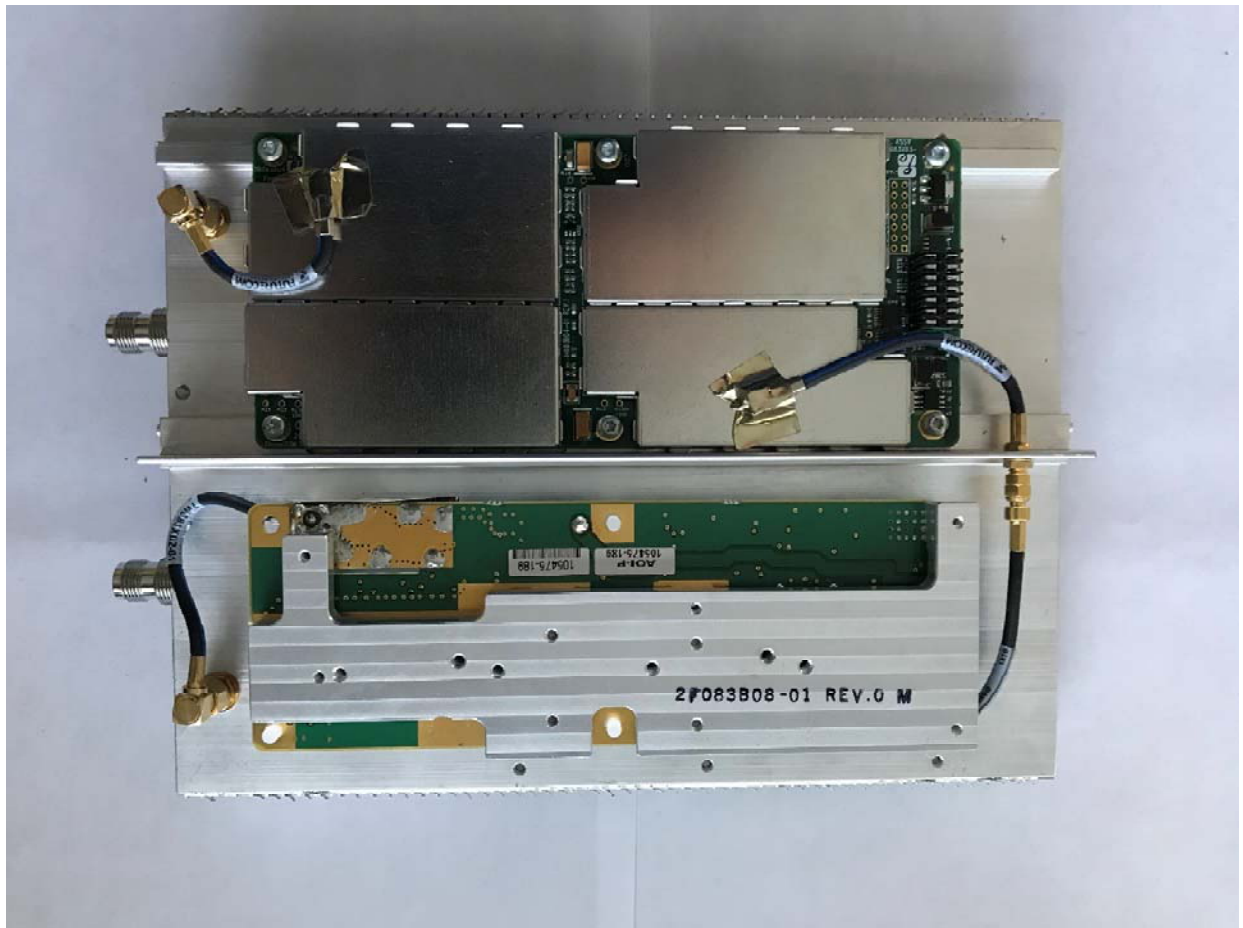
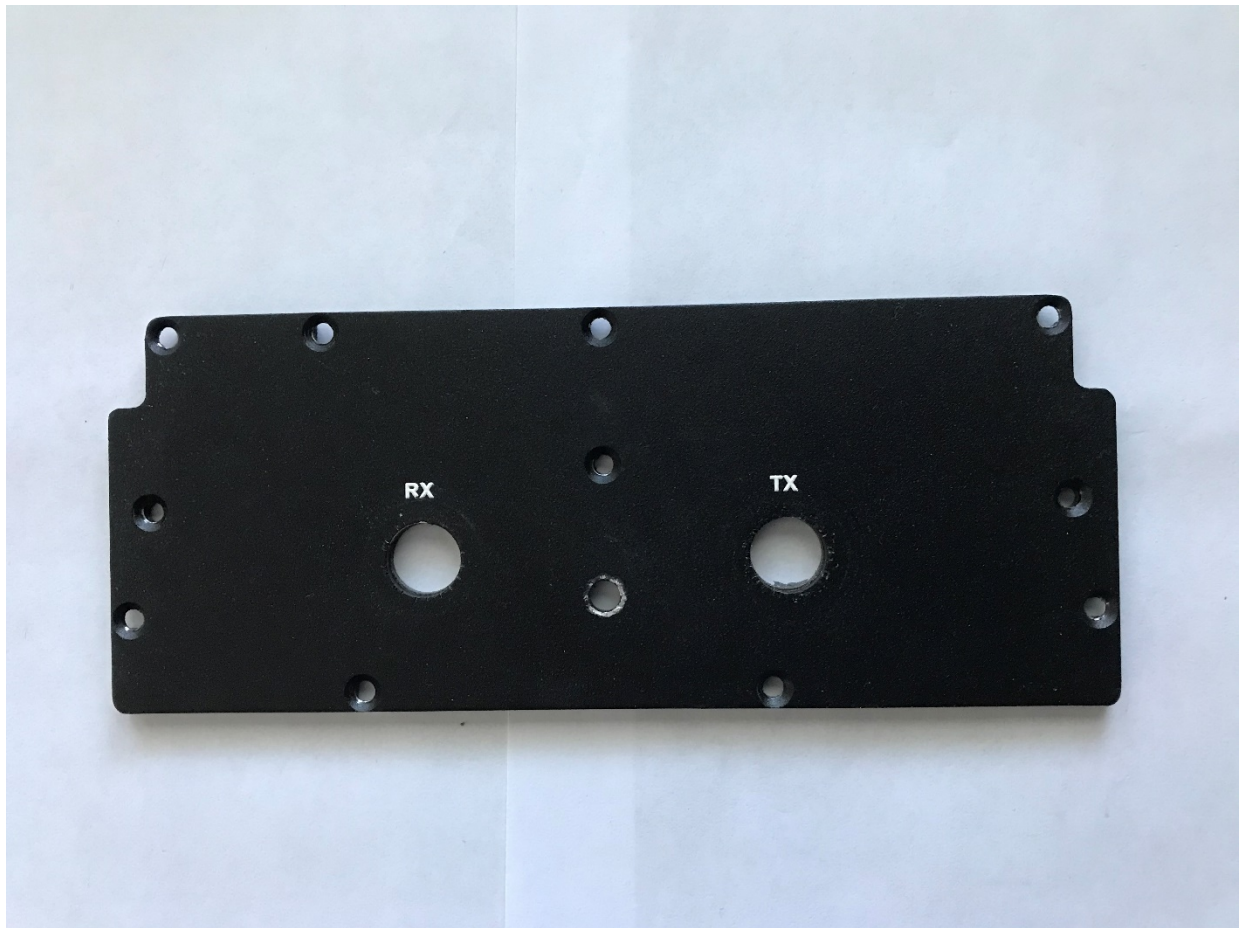
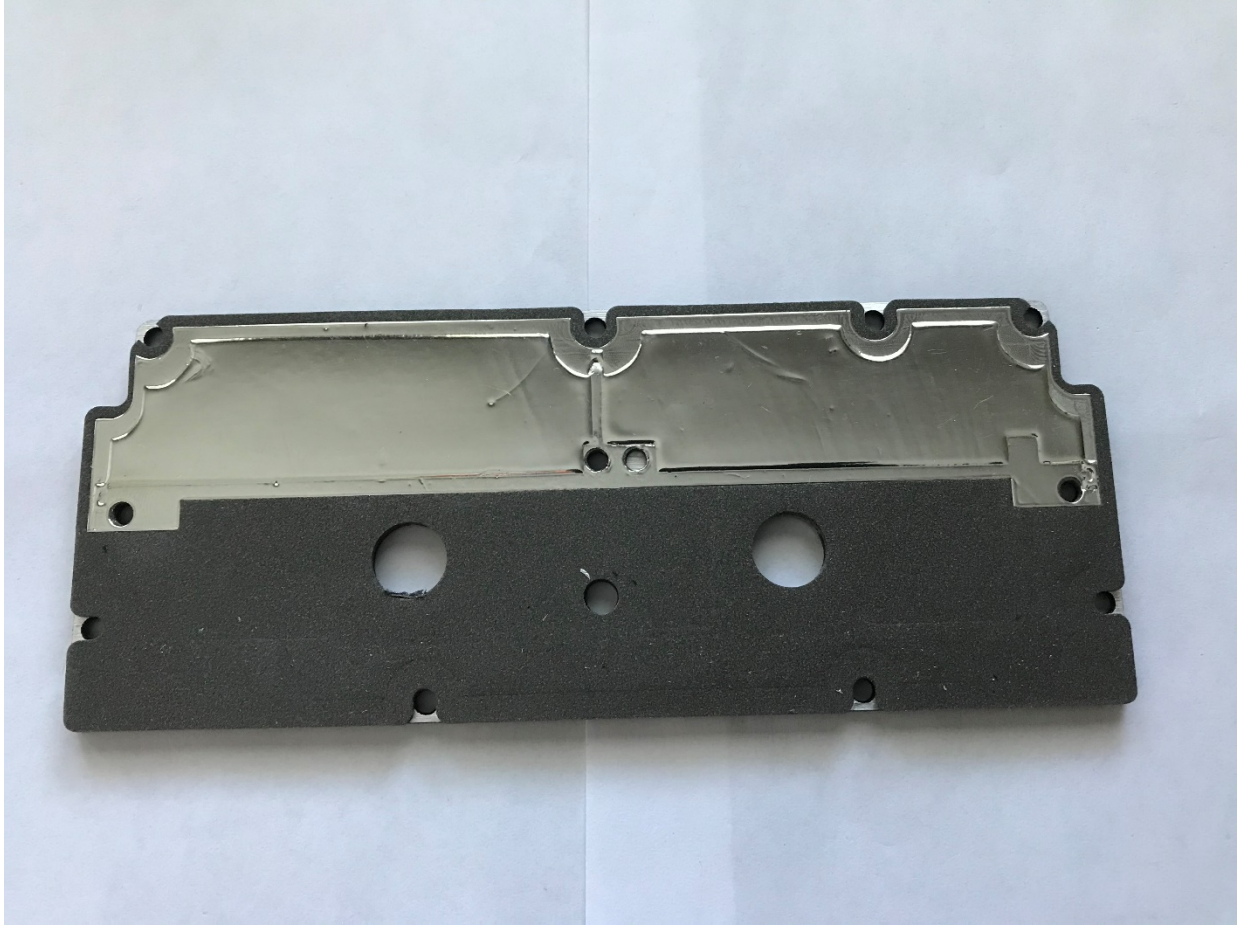
Finger stock was added on both long partition edges.

The cover is 4mm larger and the upper corner screws were added

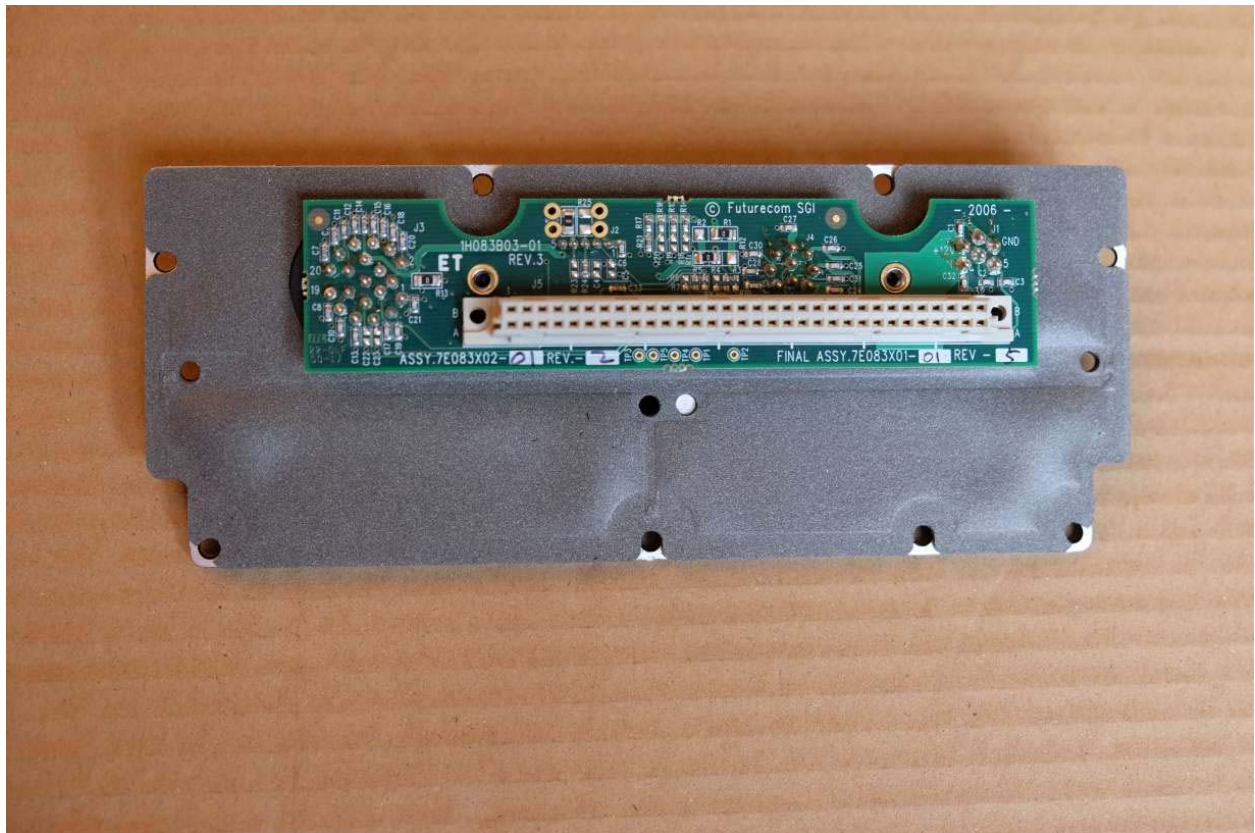
Foil was added on the EMI gasket

The cover is 4mm larger and screws were added in upper corners.

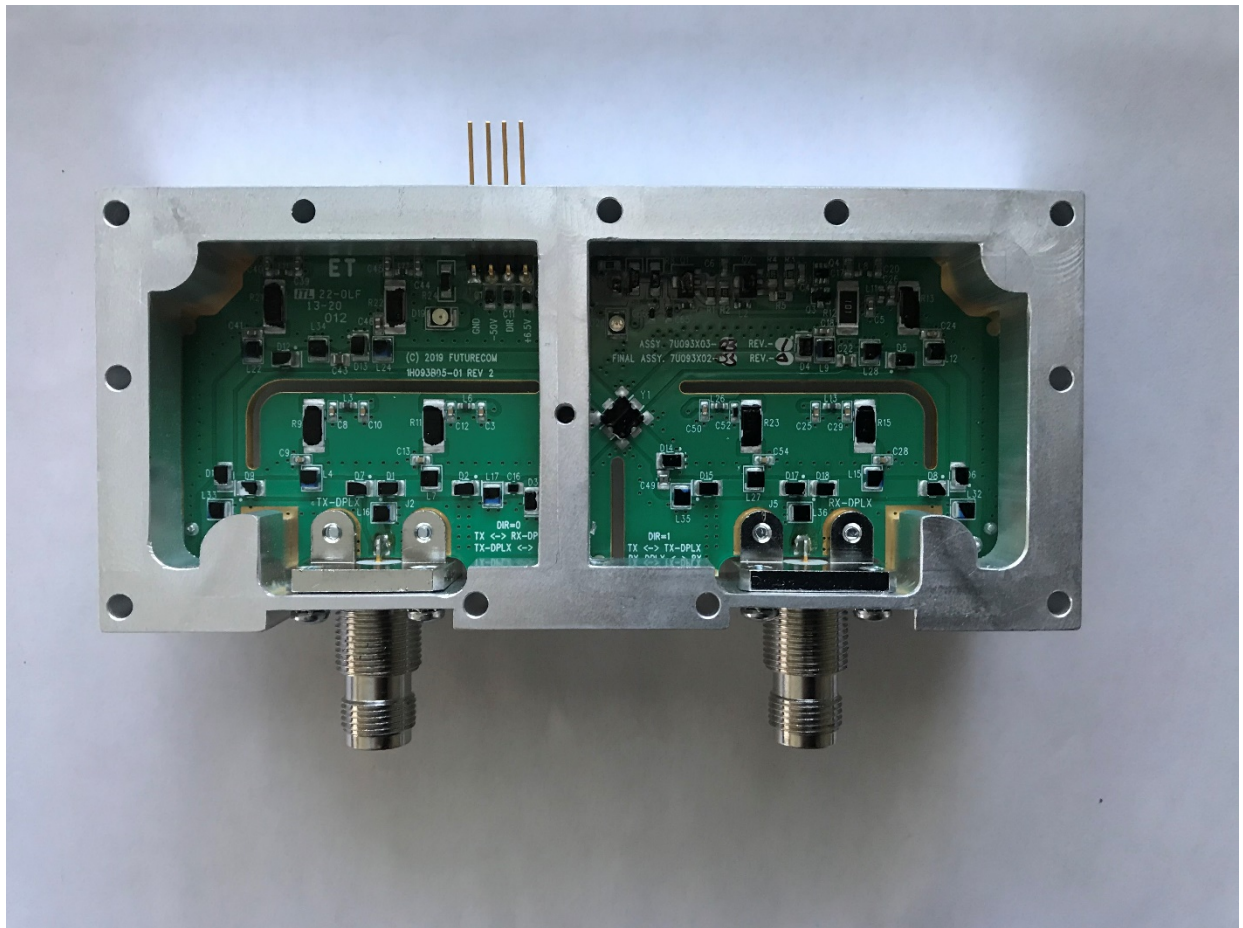
The cover now displays DVR-LX.

New TNC connectors.
